RE: **P.Z. 18-2021 Legends at Schoettler Pointe (Stock and Associates):** A request for a zoning map amendment from an “E-1/2 AC” Estate One-half Acre District to a “PUD” Planned Unit Development for 9 acres located on the south side of Outer 40 Road and east side of Schoettler Road (19S640152 & 19S640657).

Planning Commission Staff Report

Petition: **P.Z. 18-2021 Legends at Schoettler Pointe (Stock and Associates)**: A request for a zoning map amendment from an “E-1/2 AC” Estate One-half Acre District to a “PUD” Planned Unit Development for 9 acres located on the south side of Outer 40 Road and east side of Schoettler Road (19S640152 & 19S640657).

Figure 2: Preliminary Plan

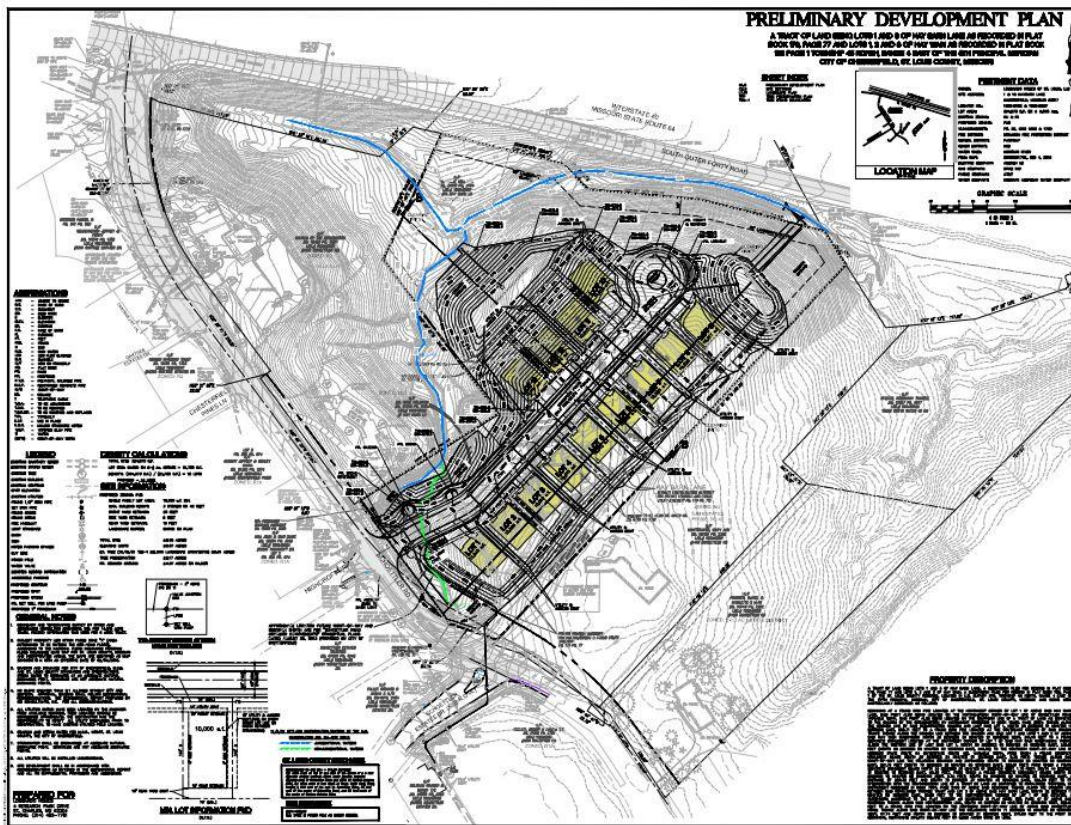
Concerns were raised regarding the topography of the site. Specifically, discussion was held over the significant grade change on the west and north of the subject site. Provide further information on how the development team will be addressing the grade change including the height and description of any retaining walls that will be used to facilitate the development. Also identify any impacts on the adjoining property to the west.

Concerns were raised regarding the proposed amenities on the site. It was also stated by the development team that additional amenities may be provided. Provide clarification and/or description of the additional amenities and provide a response on the appropriateness on the amount of amenities in relation to the proposed development.

A discussion occurred in regards to the landscape buffer along the eastern property line. It was stated that an additional fifteen (15) foot landscape buffer will exist beyond the depicted thirty (30) foot landscape buffer. Provide additional detail on plan location, how the buffer will be established, and who will be obligated for its maintenance.

Response: The proposed grading does not impact adjoining properties, project disturbance contained within the subject property. Site design utilizes retaining walls, varying in height from 1.0 -20.0 feet tall and limited to the northeast portions of the site, in an effort to balance the earthwork at 30,000 cubic yards and meet the City of Chesterfield's Unified Development Code standards for street grade.

Response: Legends at Schoettler Pointe will have four amenities located near the main entrance and at the cul-de-sac. The main entry will have a gazebo and couples swing, both with tiered retaining wall and ornamental plantings. A firepit with benches will be placed inside the island of the cul-de-sac. A "lookout"/pedestrian gathering space with benches, pavers, and ornamental plantings will be located along the outside of the cul-de-sac. Please refer to the Preliminary Development Plan and Landscape Plan for amenity locations.

Response: Please refer to Preliminary Development Plan for the location of the additional 15.0' buffer, buffer spans the rear of Lots 1-9. The maintenance of the additional 15.0' landscape buffer will be the responsibility of the Homeowner's Association.

SHEET NO.: C1.0

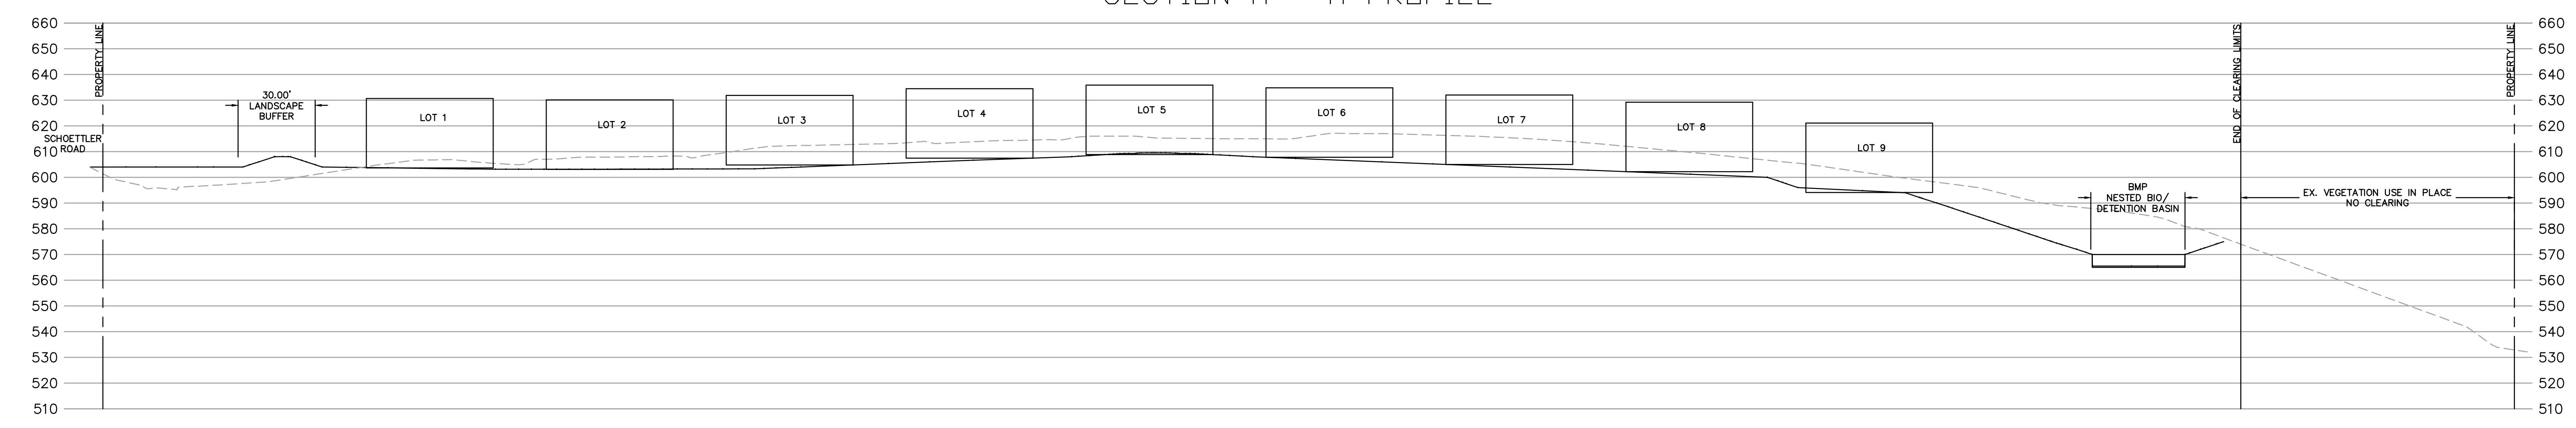
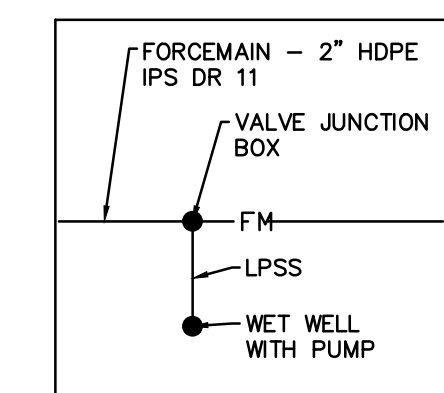
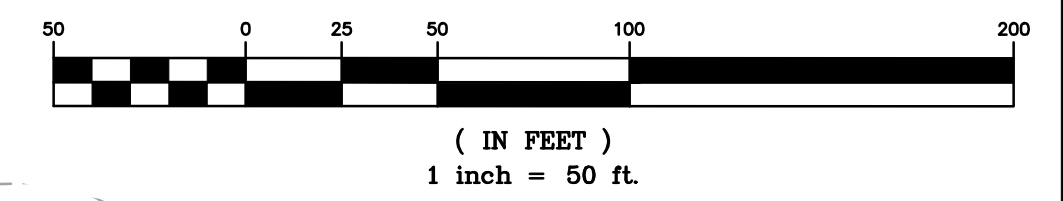
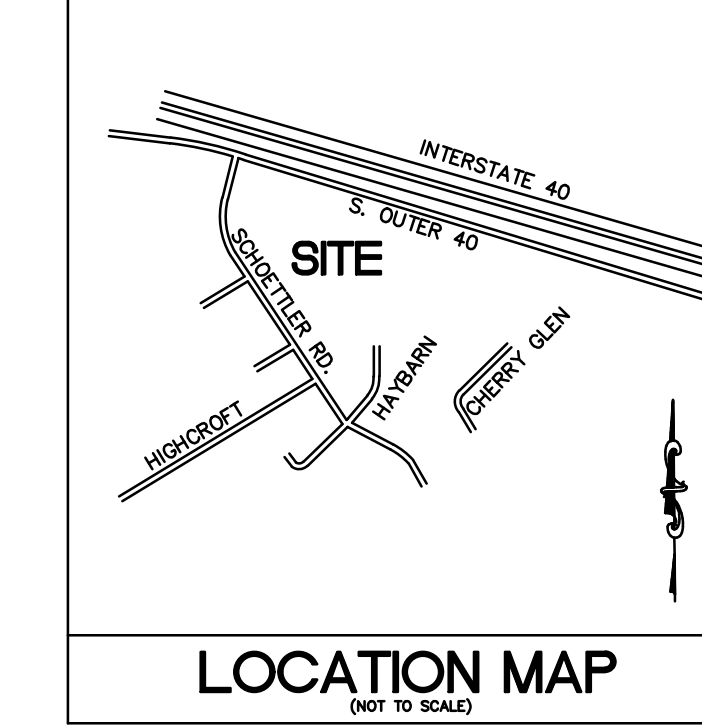
1. Please label the proposed road as a public or private street along with street width on the plan.

4. Revise the graphic scale on the Preliminary Development Plan sheet to be to scale.

1. The proposed lot layout encroaches upon the following easements as shown on the Boundary Survey: an existing 20'w Easement, 10'w Easement to Laclede Gas Co., Easement to St. Louis Co. Water Co., and a Public Utility Easement. The utilities located within said easements must be relocated around the proposed improvements. New easements encompassing the relocated utility locations must be dedicated and recorded prior to Improvement Plan approval. The existing easements must also be vacated, and the vacations must be recorded prior to Improvement Plan approval.

2. The existing Haybarn Lane private ingress/egress easement for private roadway must be vacated and recorded prior to Improvement Plan approval.

Response: Please see Preliminary Development Plan, Schoettler Pointe is Public, 50.0’ right-of-way & 26.0’ feet of pavement.

Response: Graphic Scale is to scale, please see Preliminary Development Plan.

Response: Understood.

Response: Understood.

SHEET TITLE:
 SITE SECTIONS
 SHEET NO.:
C2.0

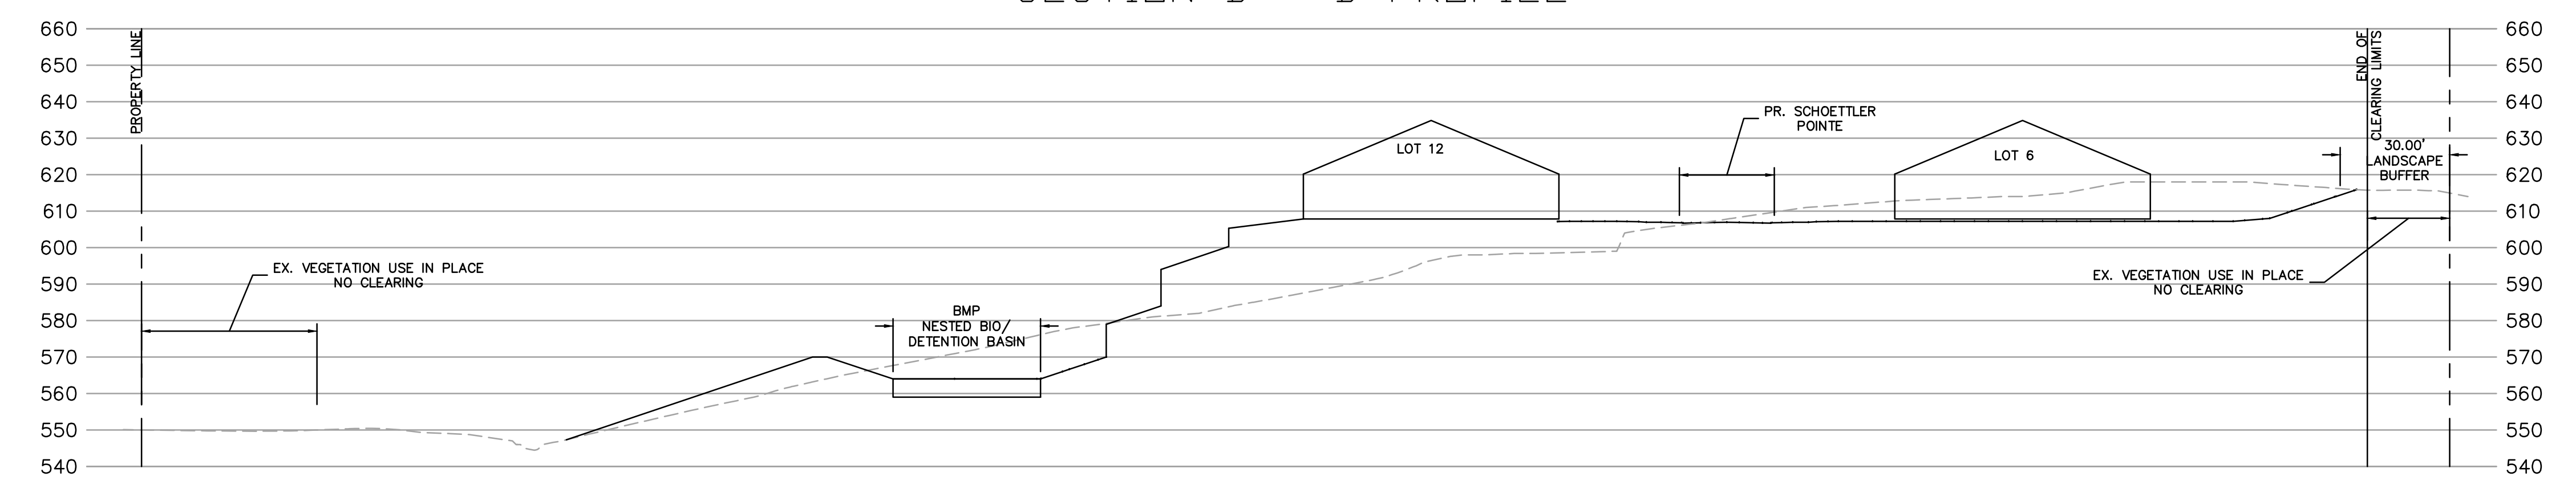
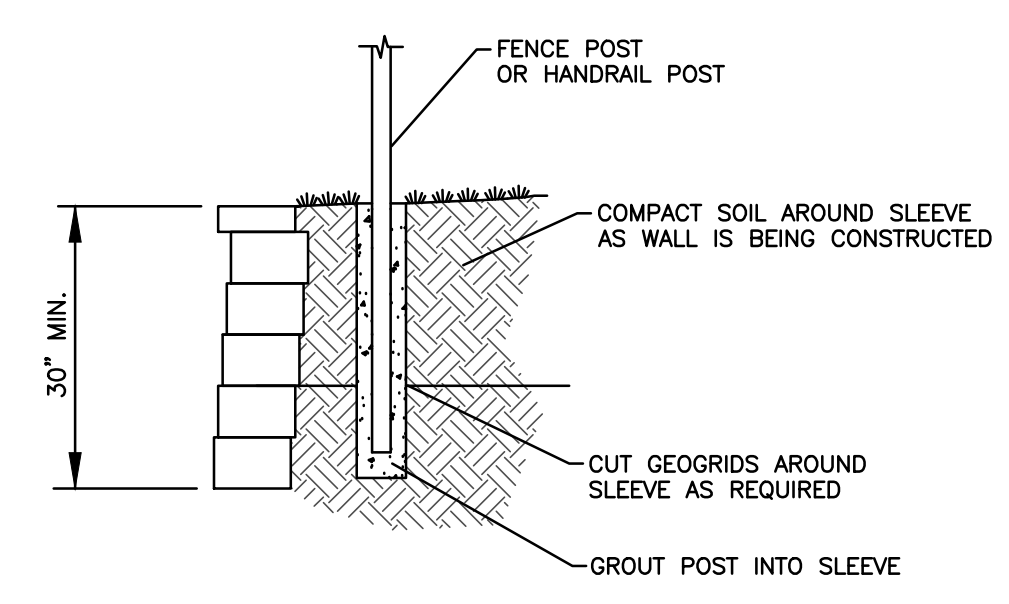
2. Concerns were raised regarding the topography of the site. Specifically, discussion was held over the significant grade change on the west and north of the subject site. Provide further information on how the development team will be addressing the grade change including the height and description of any retaining walls that will be used to facilitate the development. Also identify any impacts on the adjoining property to the west.

Response: The proposed grading does not impact adjoining properties, project disturbance contained within the subject property. Site design utilizes retaining walls, varying in height from 1.0-20.0 feet tall and limited to the northeast and northwest portions of the site, in effort to balance the earthwork at 30,000 cubic yards and meet the City of Chesterfield's Unified Development Code standards for street grade.
